Service Bulletin

SUB-C200229

Product Update: Steam Valve

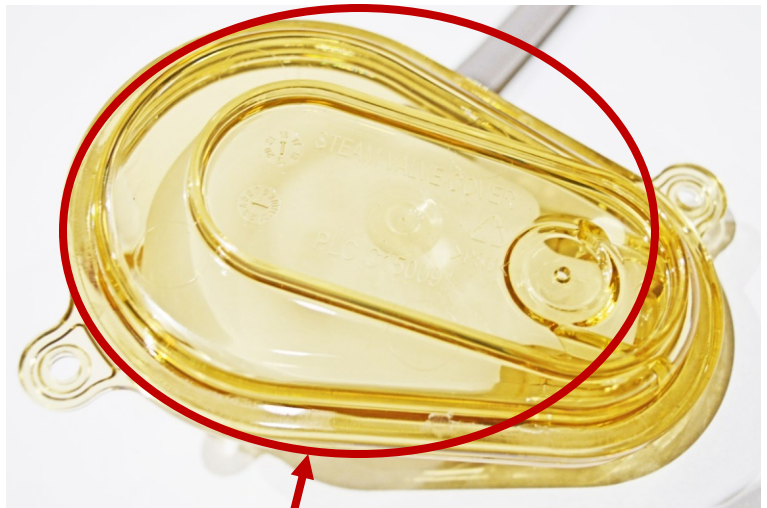
As part of our dedication to continuously improve our product, Crystal Mountain has changed the construction of the Steam Valve used in the Storm, bottom load, water cooler. Previously the steam valve had a circular, sealed float which was used to close the steam vent opening during usage. The circular float has been replaced with a “D” or oval shaped float which is bottomless. The previous float was the same clear, amber colored plastic as the steam valve body while the new design uses a white plastic float body.

All new production will use the updated steam valves once the older parts are used up by production. The same will hold true for spare parts. All orders will be fulfilled using the new parts once stock is depleted. A new part number will be utilized at that time.
